CALIFORNIA COASTAL COMMISSION

STAFF RECOMMENDATION

ON CONSISTENCY DETERMINATION

Consistency Determination No.	CD-008-06
Staff:	LJS-SF
File Date:	2/01/2006
60 th Day:	4/02/2006
75 th Day:	4/17/2006
Commission Meeting:	3/10/2006

EXHIBIT NO. 3	
APPLICATION NO.	
(D-008-06

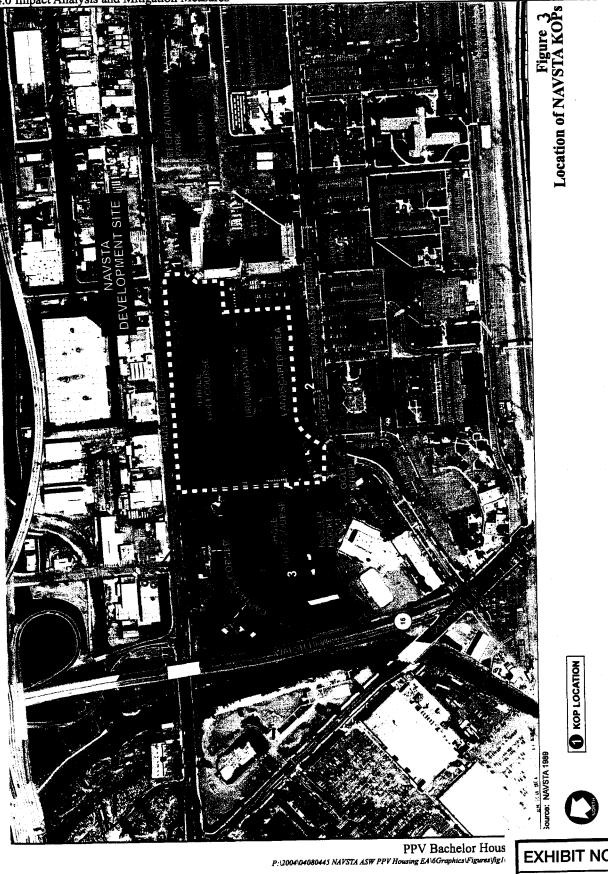
In terms of land use, the Commission agrees that the proposed military housing project is consistent with the adjacent and surrounding residential land uses on the base. However, the Commission disagrees with the Navy's determination that the proposed high rise towers would not adversely affect visual resources within the coastal zone. Prior to the analysis of this issue, a point of clarification regarding an element of the proposed development is required. The consistency determination states that the project includes *three* 18-story buildings. While this is technically correct when looking at the building footprints, *four* 18-story-tall high rise towers would in fact be constructed. The two easterly towers would arise from a shared building base and would be connected by a 9-story-tall portion of the building, on top of which would be placed an outdoor swimming pool (**Exhibit 4**).

The proposed 18-story high rise towers at NBSD represent a significant increase in height over the three existing 8-, 10-, and 12-story towers at NBSD and as designed would contribute to a cumulative degradation of public views that presently exist towards the bay out across the built (and relatively low-rise) landscape of NBSD. The photo illustrations submitted by the Navy (**Exhibits 5-8**) to support its position that the proposed buildings will have a negligible impact on visual resources are, in the Commission's view, actually supportive of the Commission's position that the project's height, bulk, and footprint will create adverse impacts to visual resources by introducing a scale and intensity of development that does not exist on the eastern shoreline of San Diego Bay south of downtown San Diego. The Commission finds that, as proposed, the project would not be visually compatible with the character of the surrounding area, would not protect scenic views from southbound Interstate 15 (a primary public access route to the southern San Diego Bay area) towards San Diego Bay, and would therefore be inconsistent with Section 30251 of the Coastal Act. The Commission further finds that the proposed project would be inconsistent with the requirement of Section 30250(a) to avoid cumulative effects on coastal resources (which include visual character).

The U.S. Navy will prepare a revised site plan for military housing in high rise buildings at the golf course/driving range site that would protect scenic views of San Diego Bay from southbound Interstate 15 at and near the junction with Interstate 5. Proposed high rise residential towers should be no taller than the existing high rise towers adjacent to the project site and should be rearranged closer to the existing towers to the degree possible so as to concentrate high rise development and protect existing views from I-15 south and west across NBSD towards southern San Diego Bay.
